# hill thalis

## **Letter of objection**

### **Barangaroo MP 06-0162 MOD 4 (Hotel Development, additional GFA and height)**

Figure 30 – Observatory Hill view – Concept Plan Modification 4

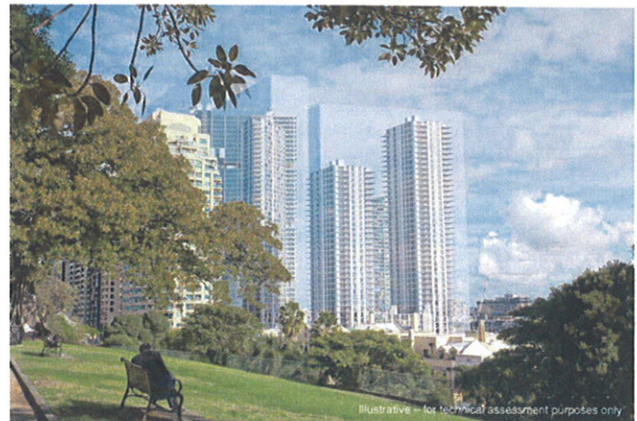
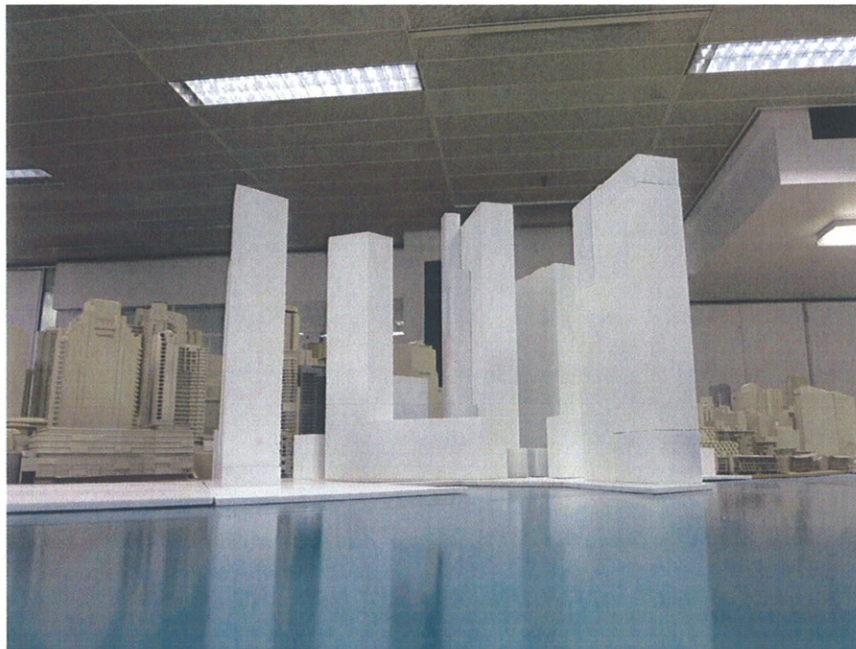
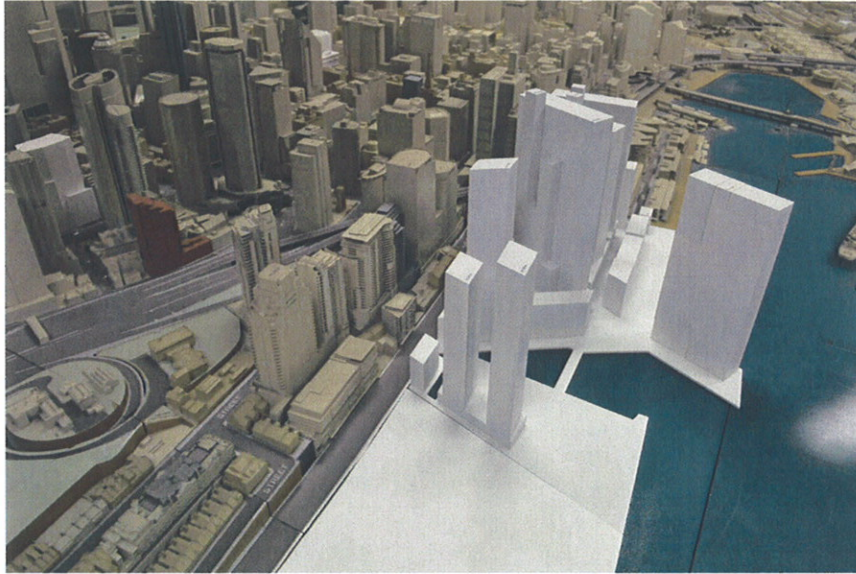
We submit that the perspective views submitted in the applicant's View Analysis are flawed due to an unacceptably wide-angle viewpoint being used to distort the proposed building forms. For some clarity regarding the enormous increase in bulk and scale that is being proposed, we have downloaded the view analysis from the approved Concept Plan on the Barangaroo Development Authority's website (Appendix L - [http://www.barangaroo.com/concept\\_plans.cfm](http://www.barangaroo.com/concept_plans.cfm)) and present the before and after views side by side for comparison.

The new perspective views are presented at a scale that makes it impossible to ascertain detail. Even so, comparison with the images in the approved Concept Plan, the massive increase in bulk and scale is extraordinarily apparent.

Comparison of the applicant's montages with the City Model at Town Hall houses suggests that the montages may seriously under-represent the scale of the proposed amendment.

All of the views in the approved Concept Plan's View analysis report should be updated and placed side by side – with the proposed new views. This should be released publicly so that the increase in bulk and scale being sought is apparent – and that members of the public can make

Public Domain comparison - Globe Street - before and after  
Shows complete reduction of amenity, scale and civic importance in new proposal

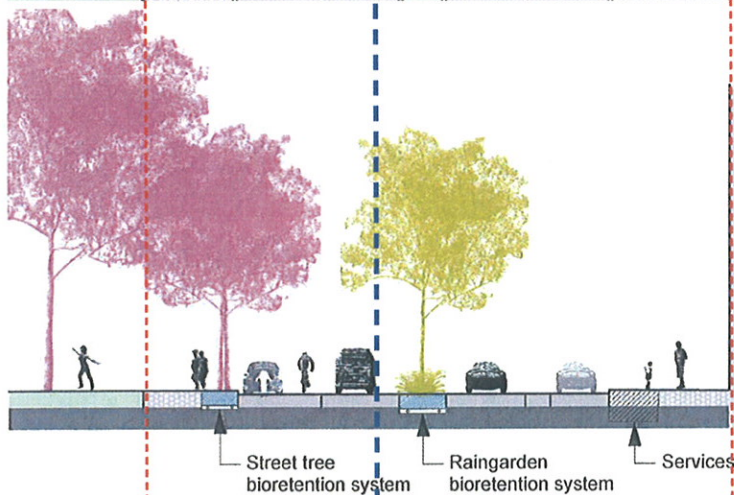
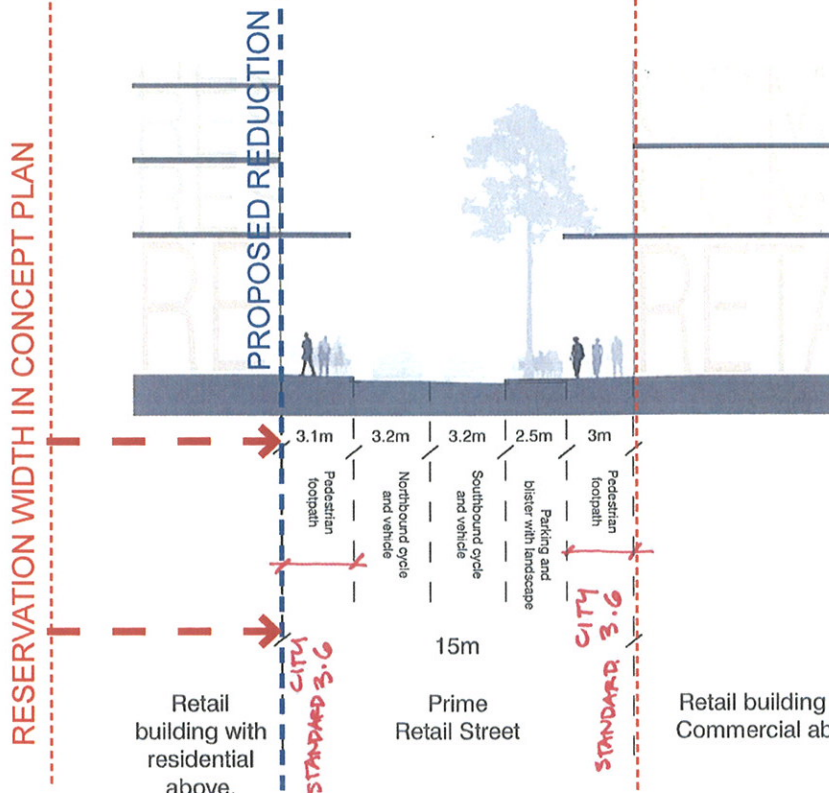
Globe Street was 24.5m wide and originally over deep soil so WSUD was integrated into all proposed streets and large street trees could be planted. The street opened to the foreshore park.

Now the reservation has been reduced to a pathetic 15m, footpath dimensions don't meet the city standard, large trees and WSUD have been removed as this street will be over the carpark structure below. The street is wedged between commercial frontages and has no public scale or civic presence whatsoever.

Public Domain comparison - Napoleon Street - before and after  
What was a grand urban street is now a small, dark pedestrian mall.

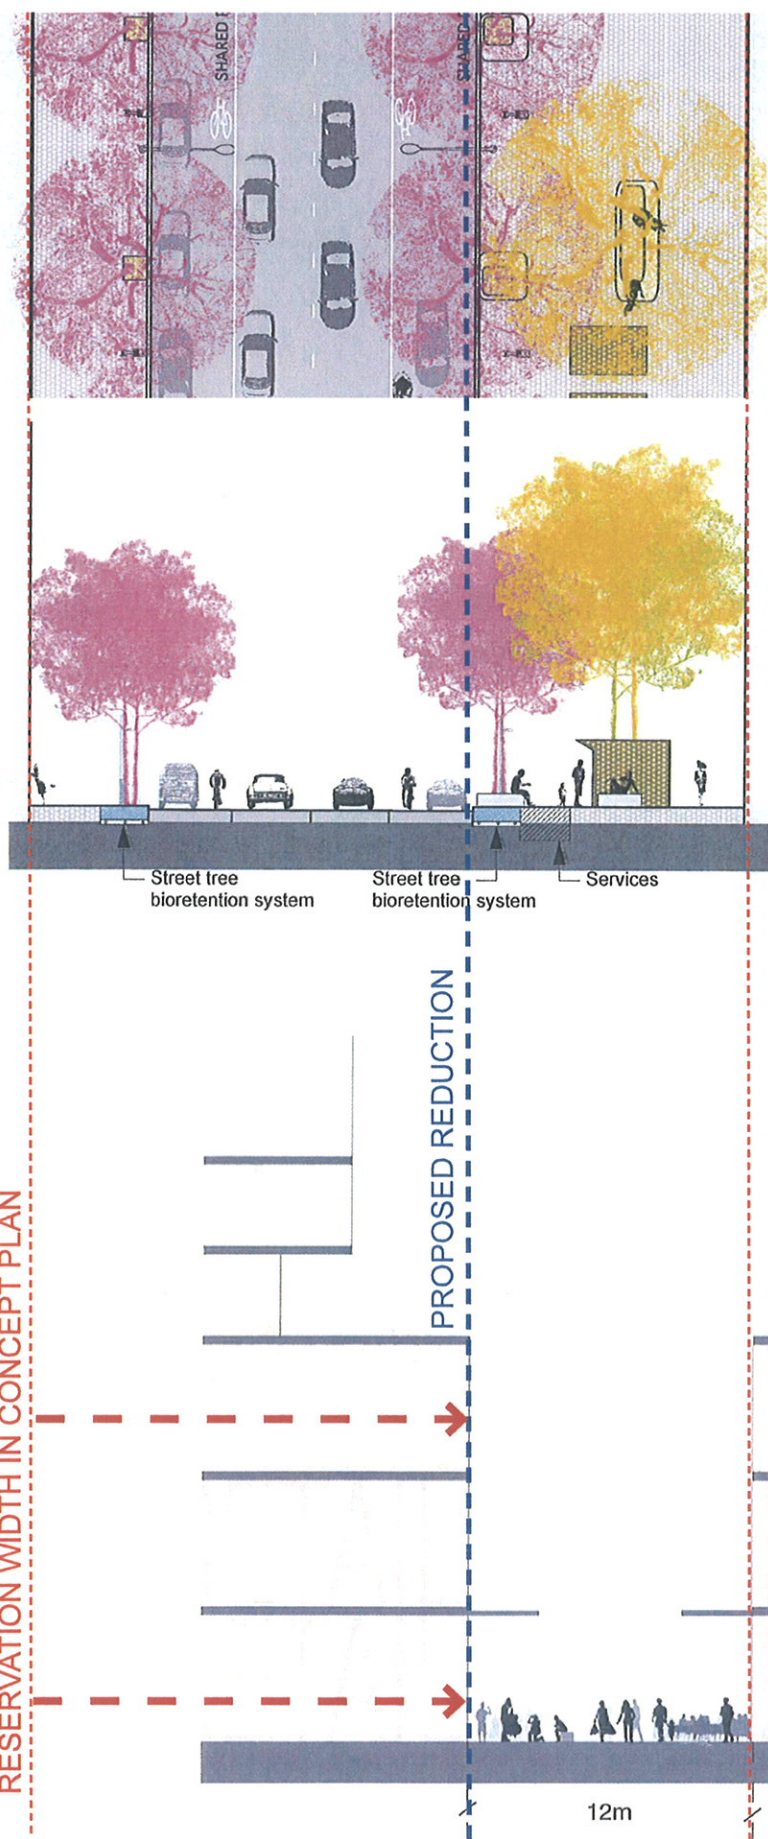
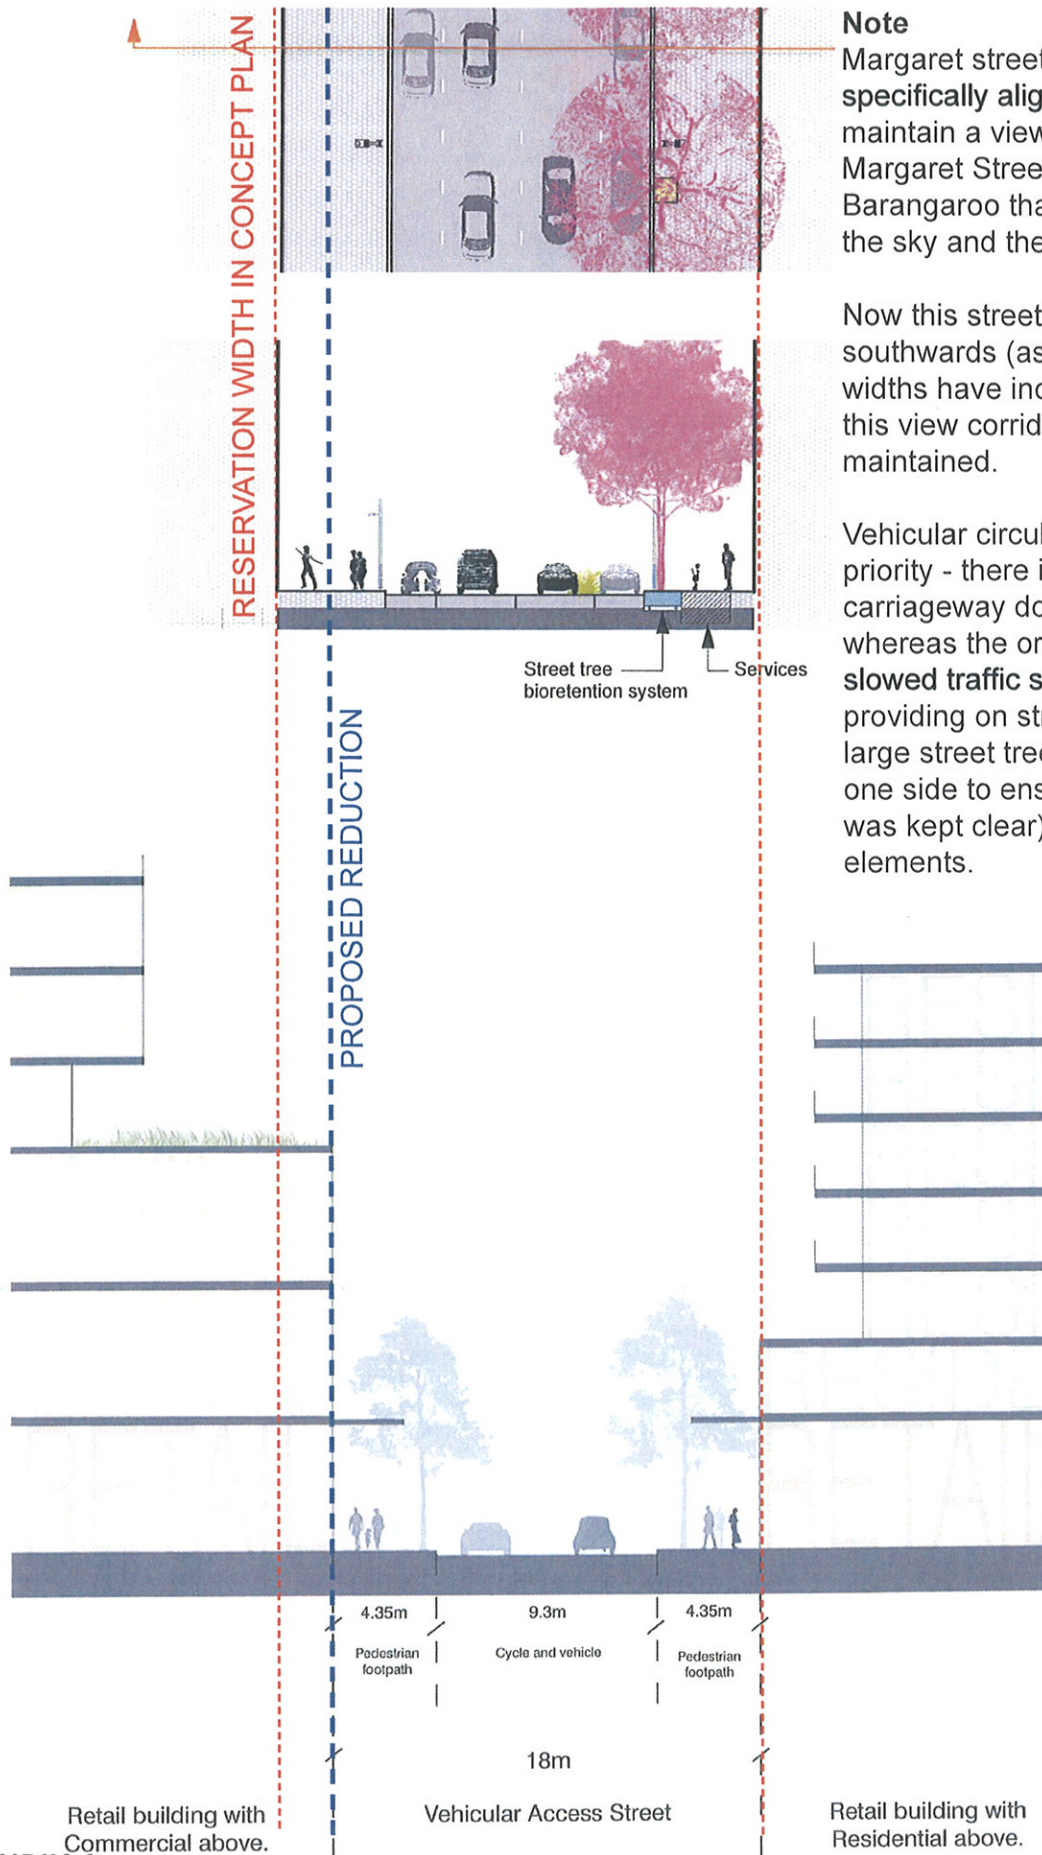
Napoleon Street was the major entry into the site from the sweep of Napoleon Street. This street was 30m wide and allowed vehicular access, deep soil planting with large trees, WSUD elements and an 11.4m wide footpath for pedestrians.

Now this has become a 12m wide pedestrian mall.  
It has no deep soil planting  
No public or civic scale  
No vehicular access  
No WSUD.
